This Service Information bulletin supersedes S.I. B23 01 04 **dated May 2004.**

| E46 M3 with the S54 Engine from the start of production through 3/31/04. |

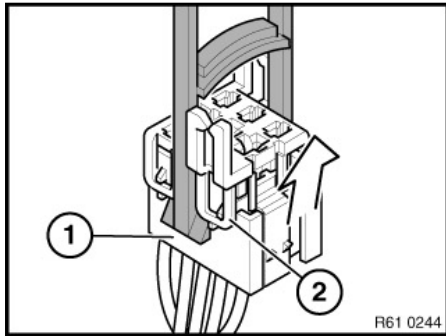
UPDATE! Using special tool 61 1 153, pull relay carrier (1) in the direction of arrow until the retaining lugs are raised.

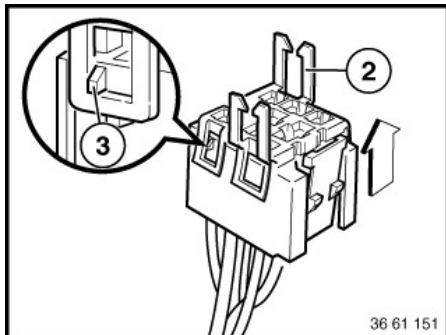
UPDATE! Using special tool 61 1 153, pull relay carrier (1) in the direction of arrow until the retaining lugs are raised.

UPDATE! Pull relay carrier (2) into first catch (3).

UPDATE! Using connector extractor 61 1 136 located in extractor kit # 61 1 150, carefully release the hooks (4) from the red terminal 87 wire from slot 2 of the relay connector and the red/yellow terminal 30 wire from slot 6. Swap wire positions by relocating the red terminal 87 wire into slot 6 and the red/yellow terminal 30 wire into slot 2.
